**Detailed Site Plan**  
**Departure from Design Standards**  
**Departure from Sign Design Standards**  
**Laurel Hospital Property**

**DSP-19049**  
**DDS-667**  
**DSDS-707**

STAFF REPORT

SUBJECT: Detailed Site Plan DSP-19049  
Departure from Design Standards DDS-667  
Departure from Sign Design Standards DSDS-707  
Type 2 Tree Conservation Plan TCP2-031-09-02  
Laurel Hospital Property

Figure 4: Signage Examples

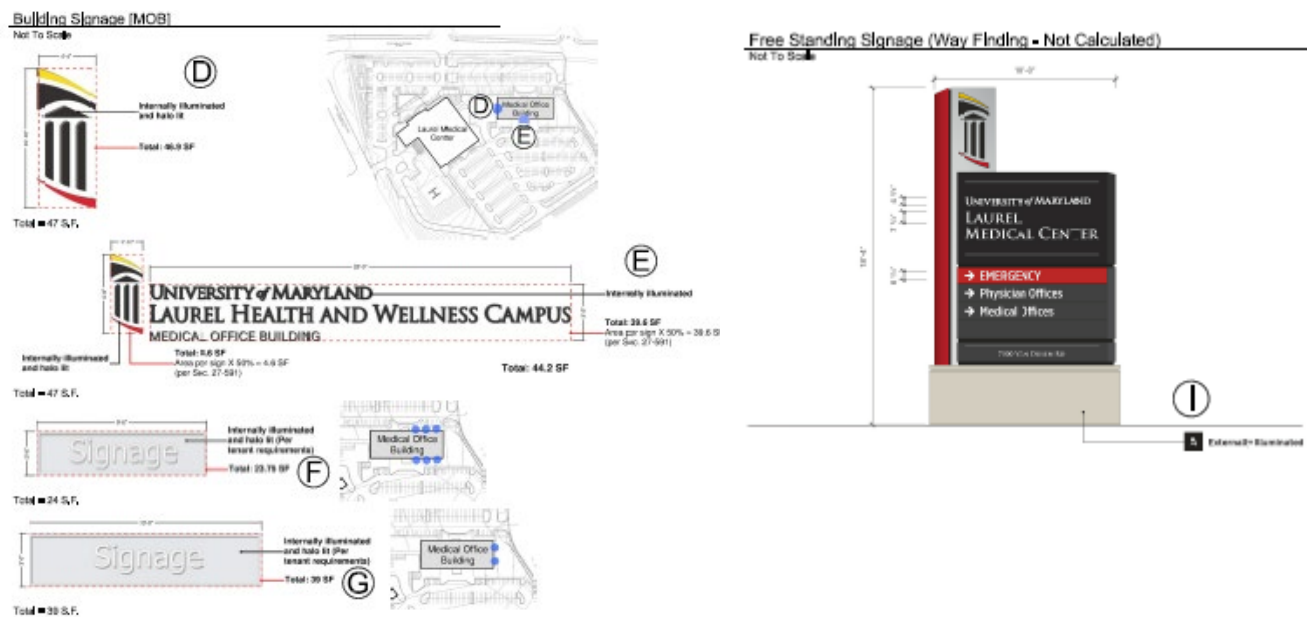
- e. **Departure from Sign Design Standards DSDS-707:** A total of 17 freestanding and building-mounted signs are proposed for this development. These signs include 3 freestanding entrance identification signs, 1 freestanding monument sign identifying the Laurel Medical Center campus, and 13 building-mounted signs identifying building names, entrances, and tenant identification. As an institutional development, associated signage is required to conform to the requirements of Section 27-617(a) of the Zoning Ordinance. The applicant has requested a DSDS, in accordance with Section-27-612 of the Zoning Ordinance, to allow for taller, larger, and greater quantity of signs. Signage provided differs from the requirements of Section 27-617, as follows:

Each proposed, building-mounted sign is less than 48 square feet. Individual freestanding and monument sign areas are shown in the departure request as 48 square feet or less. However, the area for freestanding signs is not identified on the DSP and appears to be much greater than 48 square feet. The sign calculations table provided on the DSP should be corrected to reflect individual area of each of the 17 signs provided. Staff has included a condition in the Recommendations section for this detail to be included on plans.

Three freestanding signs are proposed to be approximately 18.5 feet in height above finished grade at the base of signs. The site identification monument sign is proposed to be slightly greater than 14 feet in height above finished grade at the base of the sign. Signage is not shown on architectural elevations for either building. Therefore, staff has included a condition in the Recommendation section for the DSP to be revised to identify signage locations on the architectural elevations.

Under this provision, a total of two signs would be allowed, as the property fronts on two streets. A total of 17 signs are proposed for both the freestanding medical facility and medical office building. Three freestanding signs are proposed, one each at site access point off of Contee Road, and one at the entrance off of Van Dusen Road. A fourth, freestanding, monument, identity sign is proposed at the corner of Contee and Van Dusen Roads. For both buildings, a total of 13 building-mounted signs are proposed. These include University of Maryland Medical Center identity signs, identity signage for service areas, such as the emergency department, and tenant identity signage for the medical office building.

- b. Correct DSP Sheet 7, Sign Calculations table to remove the institutional sign design standards and to provide the area and height figures for each sign proposed. Further correct the Sign Calculations table to show the correct approved departure.

- e. Revise the architectural elevations for the freestanding medical facility and medical office buildings to show signage placement for all building-mounted signage.

- B. APPROVE Departure from Design Standards DDS-667 for Laurel Hospital Property, to allow a standard, nonparallel, parking space size of 9 feet in width by 18 feet in length.
- C. APPROVE Departure from Sign Design Standards DSDS-707 for Laurel Hospital Property, to allow for a total of 4 freestanding signs and 13 building-mounted signs, with dimensions as shown on the detailed site plan.
